**PUR-1270
ADDENDUM NO. 5
INVITATION TO BID**

CONOCOCHEAGUE TREATMENT PLANT ENR UPGRADE

DATE: Thursday, May 26, 2016

B SECTION
 0 2' 4' 8'

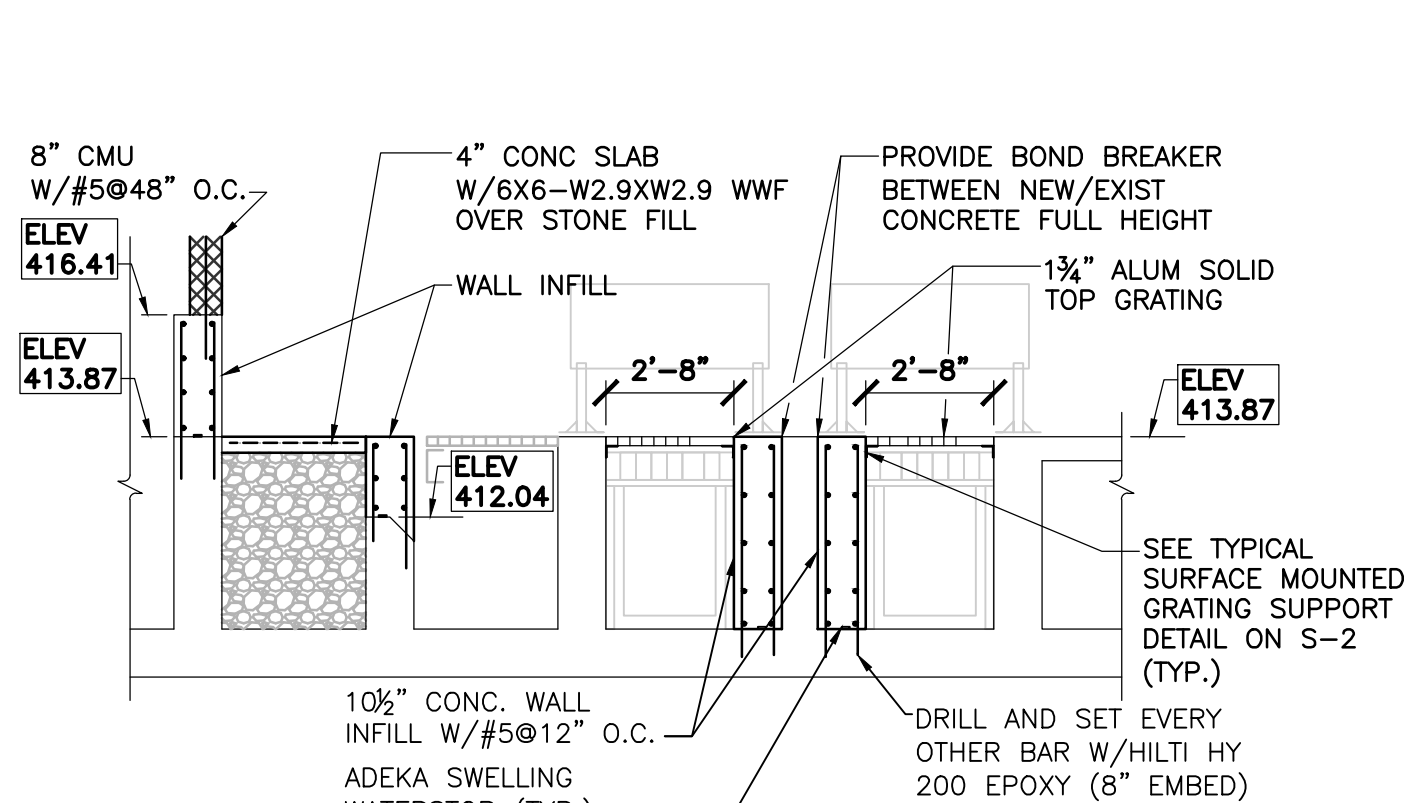
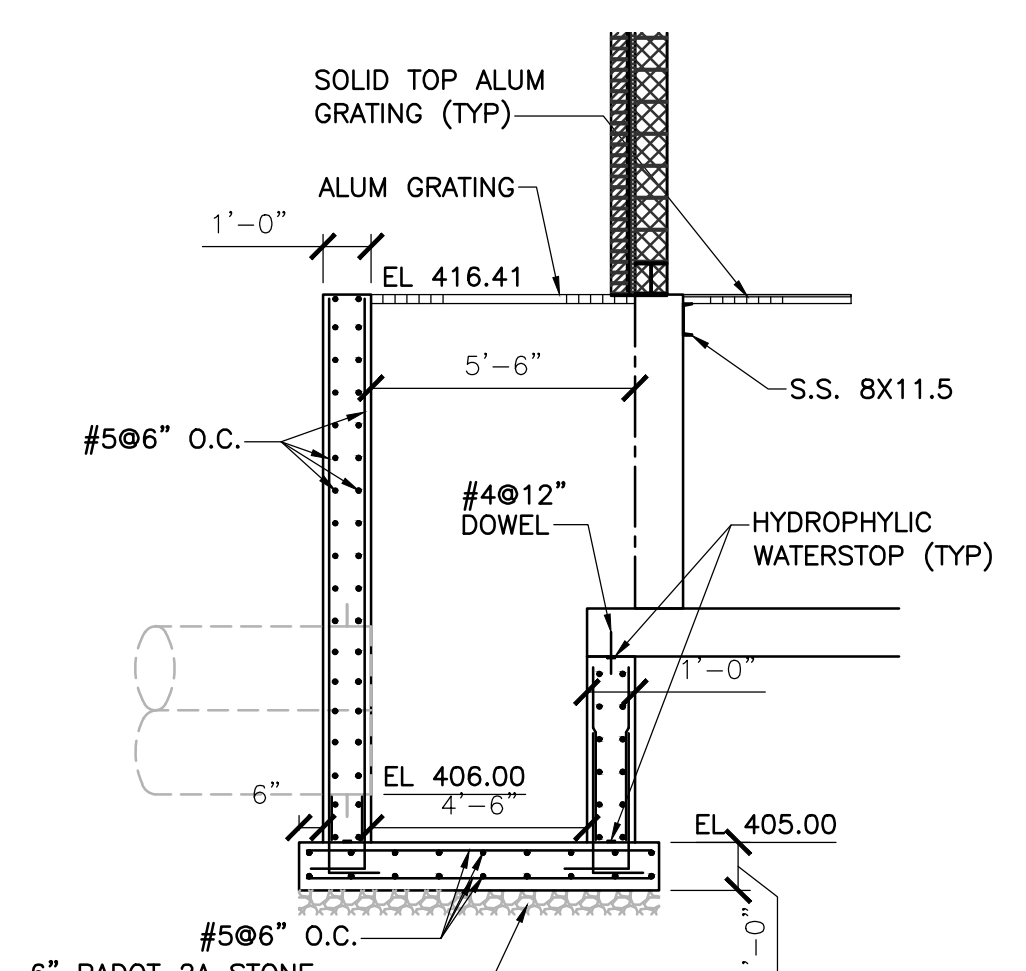
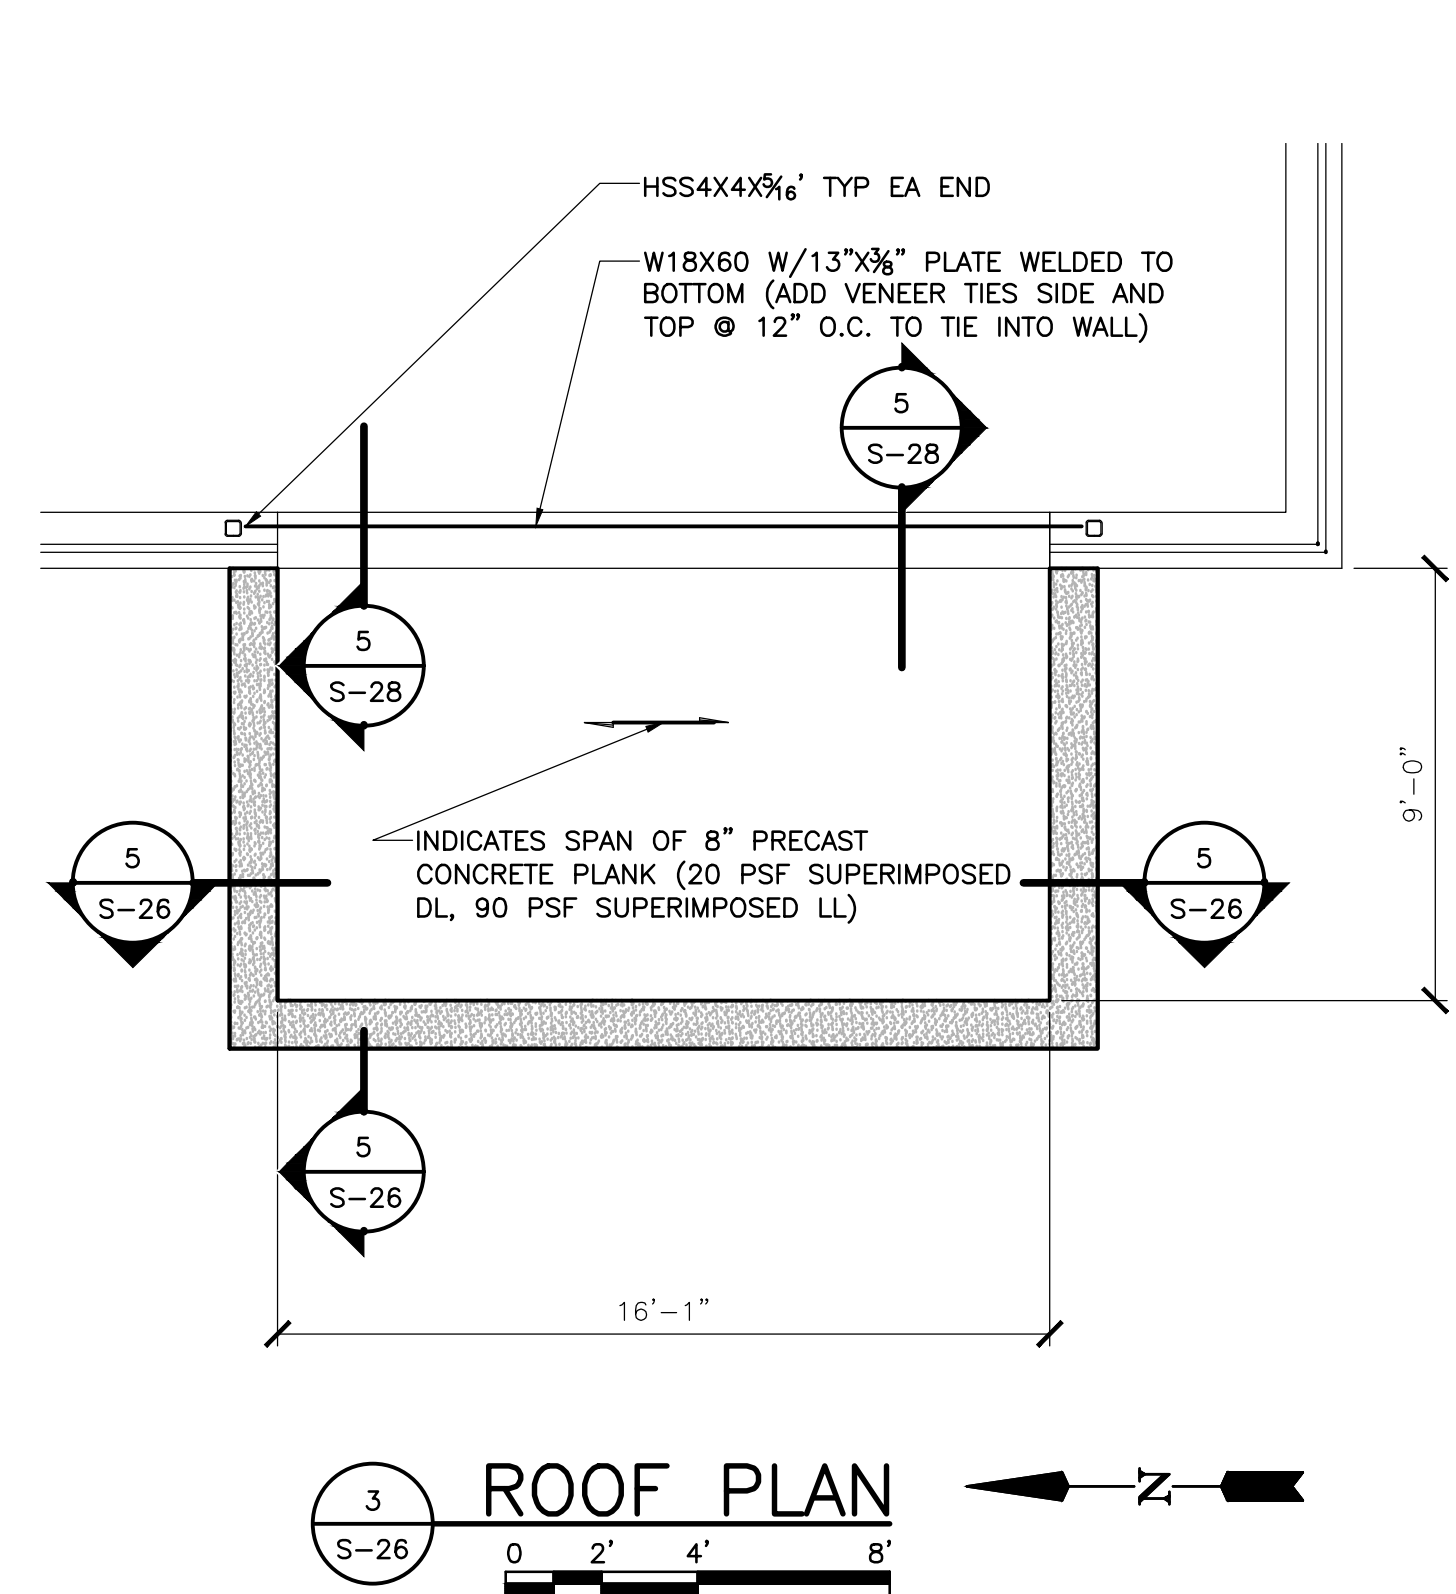
ITEM NO. 29: *Inquiry:* Drawing S-26 Filter/UV Building section 1. Will the exterior walls not shown in detail C/S-26 need to be extended in height the same as the trough walls?

ITEM NO. 43: *Inquiry:* Drawing S-26 has a note near the upper left hand corner of the floor plan (detail 1) that says existing grating & new aluminum steps see ENV drawings. Drawing PM-39 shows 3 steps leading up to something. Is what it leads up to the aluminum grating that is already there? If so, are we to remove that to fill this area with stone as shown on S-26 & then put the grating back or does this get concrete slab poured under the grating as well? PM-35 actually shows some of the grating to be removed that is existing in front of where the new door is going which we would need as part of the “platform”. Please clarify what this area is to look like when the work is done.

Response: Yes.

Response: See revised copy of Drawing No. S-26 attached to this Addendum which should better clarify the work required.
